Academy Street Development, Navan,  
Co. Meath

Quality Audit

<b>Document Ref:</b>	<b>P19-106-RP-001</b>
----------------------	-----------------------

*Summary:* Insufficient forward visibility to parking arrangements

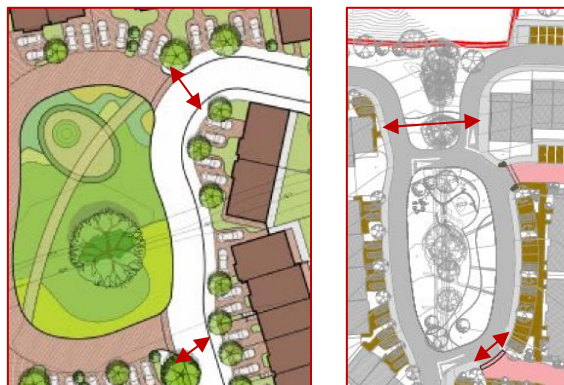
It is proposed to provide parking for residential units at bends and junctions within the development. The Audit Team are aware this is a low speed environment however, it is unclear if sufficient forward visibility is provided to drivers entering/exiting proposed parking spaces. Should insufficient visibility be provided, this may result in side-on collisions.

Ensure sufficient inter-visibility is provided between drivers continuing along main routes and cars entering/exiting parking spaces throughout the development.

*Summary:* Designated crossing points within the residential road network have not been indicated at junctions.

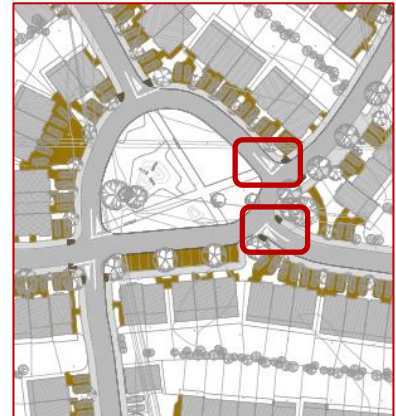
Pedestrian crossing points, including dropped kerbs and tactile paving, have not been indicated at several locations within the proposed development. A failure to provide dropped kerbs at crossing points, and along pedestrian desire lines, could result in mobility impaired pedestrians being unable to safely and independently enter the carriageway to cross to the opposite footpath. This could result in slips, trips or falls as these pedestrians attempt to descend the kerb, or where tactile paving is not provided, an increased risk of visually impaired pedestrians unintentionally entering the carriageway where they could be struck by vehicles.

Pedestrian crossings, including dropped kerbs and tactile paving, should be provided across all junctions within the proposed development, and should be located to reflect desire lines.

Summary: *It is unclear if there is sufficient swept path for vehicles entering/exiting parking spaces throughout the scheme.*

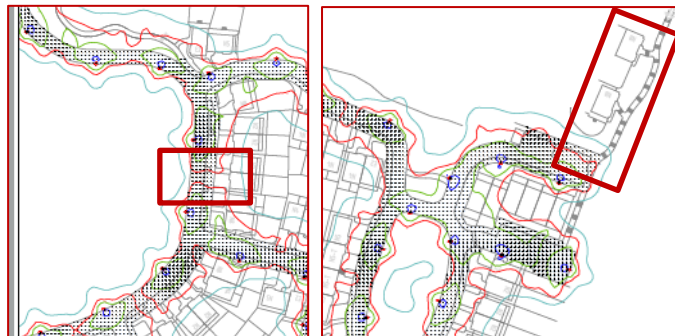
There are a number of locations throughout the scheme where insufficient swept path may be provided to vehicles entering/exiting parking spaces. This may result in vehicles having to undertake complex turning manoeuvres to access the parking spaces, leading to material damage collisions.

Swept path analysis should be undertaken to ensure sufficient turning space is provided to all car parking spaces. Where necessary, the layout should be adjusted to accommodate swept path.

*Summary: Potential dark spots within carriageway and pedestrian footpaths.*

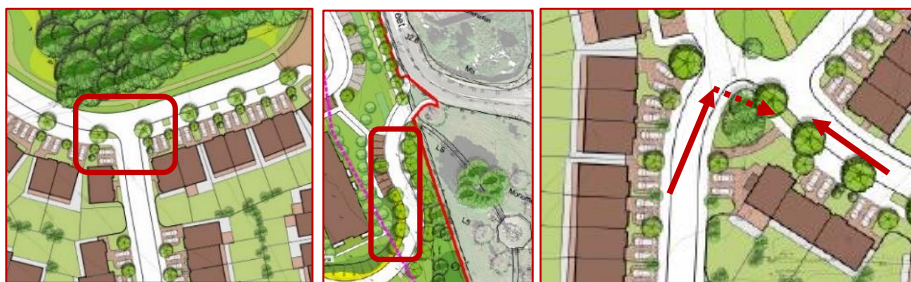
Lighting columns are proposed throughout the scheme, however, the spacing of lighting columns along carriageways may result in dark spots. Dark spots within the carriageway could result in drivers being unable to see vulnerable road users at crossings or to distinguish the edge of carriageway from the footpath leading to VRUs being struck by a vehicle or to vehicles colliding with the kerb and sustaining material damage.

Additionally, lighting columns have not been indicated along all pedestrian routes. Insufficient lighting within walkways may result in pedestrians conflicting with other pedestrians and/or cyclists, resulting in slips, trip or falls.

Sufficient lighting should be provided within pedestrian walkways and the carriageway. Lighting columns should be located to the back of the footway to maximise the effective footway width.

*Summary: Proposed trees may block visibility at junctions, pedestrian crossings and to parked vehicles within the development.*

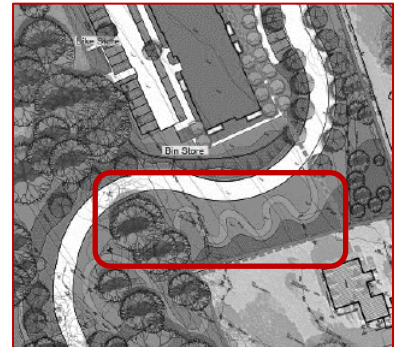
It is unclear if the proposed location of trees within verges throughout the scheme shall obstruct visibility for drivers exiting junctions and proposed parking within the proposed development. This could result in drivers exiting side roads and driveways when it is unsafe to do so ahead of oncoming vehicles leading to side-on collisions.

Additionally, the location of trees may block visibility to pedestrians attempting to cross which may result in vehicle/pedestrian collisions.

Ensure sufficient visibility is provided at all junctions, parking arrangements and pedestrian crossings within the proposed development.

Summary: Information regarding lighting along Academy Street not provided to the Audit Team

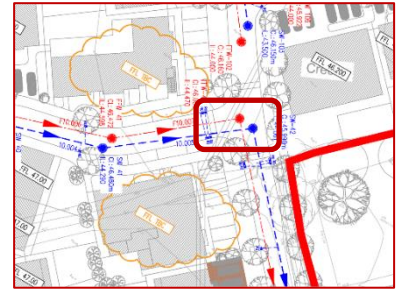
A lighting column exists where the proposed southern access to the development onto Academy Street is located. No public lighting columns have been indicated at the proposed access. A lack of public lighting provision may lead to drivers being unable to see vulnerable road users on the footway or in the carriageway during the hours of darkness, resulting in an increased risk of collisions between vehicles and vulnerable road users.

Ensure sufficient lighting is provided on Academy Street where changes are proposed.

*Summary: Visually impaired pedestrians unable to cross shared surfaces.*

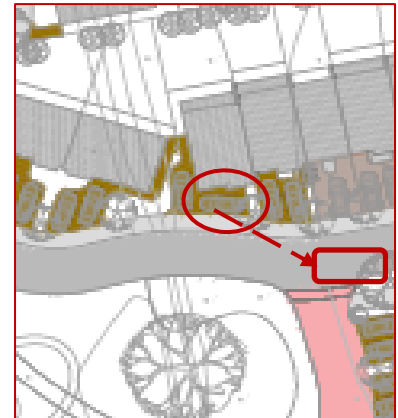
It is proposed to provide shared surfaces at a number of locations with the scheme with adjoining footpaths. Without sufficient warning, visually impaired pedestrians may continue across shared surfaces and be unable to locate the adjoining footpath. This may result in visually impaired pedestrians walking into the carriageway resulting in a vehicle/pedestrian collision.

Provide a continuous footpath across proposed parking arrangements and ensure visually impaired pedestrians are sufficiently warning of change of surfaces using tactile paving.

*Drawing: Footpath at open Space*

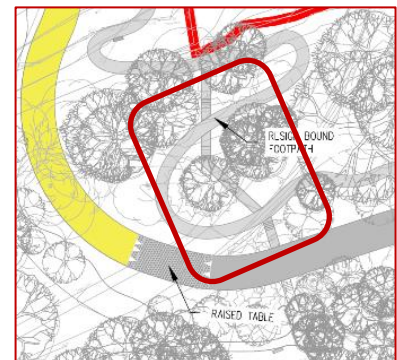
*Summary: No Hazard Tactile paving at top and bottom of steps*

It proposed to provide a spiralling footpath with an alternative footpath (with steps) crossing at a number of locations. Without hazard tactile paving at these crossings, visually impaired pedestrians may continue along the footpath with steps and be insufficiently aware of the vertical hazard. This may result in slips trips, falls and serious injuries.

Warning tactile paving should be provided at the top and bottom of steps.

*Drawing: Academy Road proposed entrance to apartment blocks*

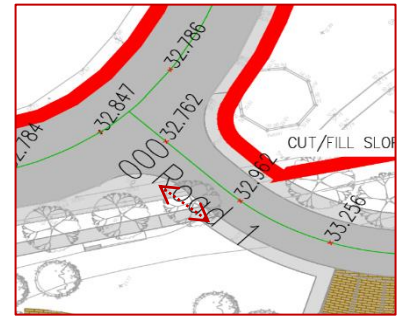
*Summary: Visibility to approaching drivers to right turners impeded.*

There is an existing construction site with hoarding on the eastern side of Academy Street. Drivers continuing north along Academy Street may have restricted visibility to right turners attempting to access the apartments. Insufficient visibility to right turning vehicles may result in side-on collisions.

Ensure visibility to vehicles entering/exiting the proposed access is sufficient for all users and is not impeded by the existing hoarding or approved future development on the eastern side of Academy Street.

### 3.3 Observations

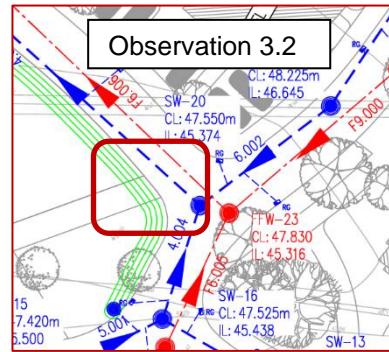
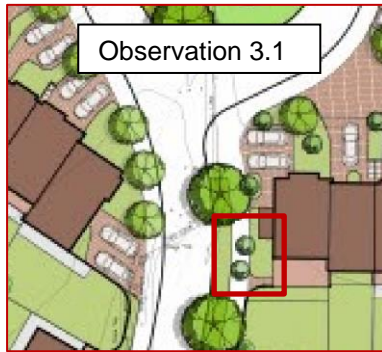
- 3.3.1 Trees are indicated within pedestrian footpaths. It is assumed this is a CAD error and trees are to be located within grass verges.
- 3.3.2 It is proposed to provide swales along the carriageway edge at open spaces. Swales are indicated within pedestrian footpaths and it is assumed this is a CAD error. It is assumed drainage will be underground for a sufficient distance either side and underneath footpaths to ensure no vertical hazards are located along pedestrian desire lines.
